Delegated officer report for planning application

Application no. 145162/NMC/2026

Proposal: Non-material amendment to Planning Permission 141607/FO/2024 to make elevational alterations and modification to landscaping.

Address: Part Of The Former Central Retail Park, Great Ancoats Street, Manchester, M4 6DJ

Figure 4.13: North Building - Approved Bay Study

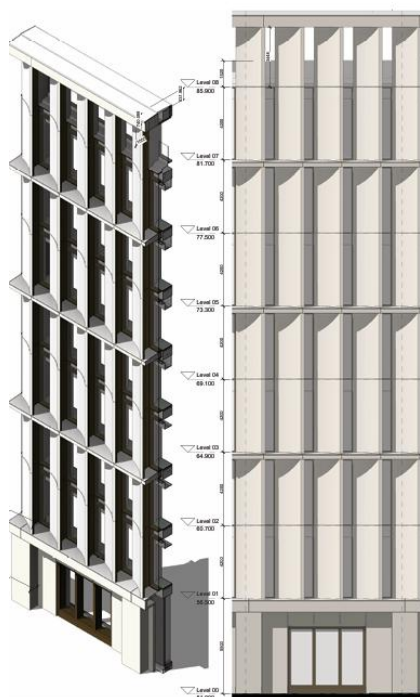
The proposal is to remove the concrete fins from the façade of the building as follows:

- 665mm facade depth reduction by removing the concrete fins and replacing them with profiled precast panels.
- By maintaining the same south facade line to the consented drawings the rear elevation now moves a total of 1,330mm south and the building misses the combined sewer easement.
- Omission of inlaid bronze element to profiled fins, replaced with polished precast element.
- Amendment to spacing of panels to provide a primary and secondary order (width of panels) and to provide a common glazing width.
- Glazed balustrade to roof level replaced with vertical railings, colour matched to metal facade elements.
- Reduction of embodied carbon associated with facade reduction and optimised supporting structure.
- It is proposed to change the glazing to opaque glazing to maintain privacy to the school to the north and provide a consistent aesthetic to all elevations.

Whilst the amendments will alter the appearance of the North Building, the design intent was to address requirements of the end user. The design and appearance of the building retains a high quality appearance with its proportions and now better aligns with the appearance of the South Building.
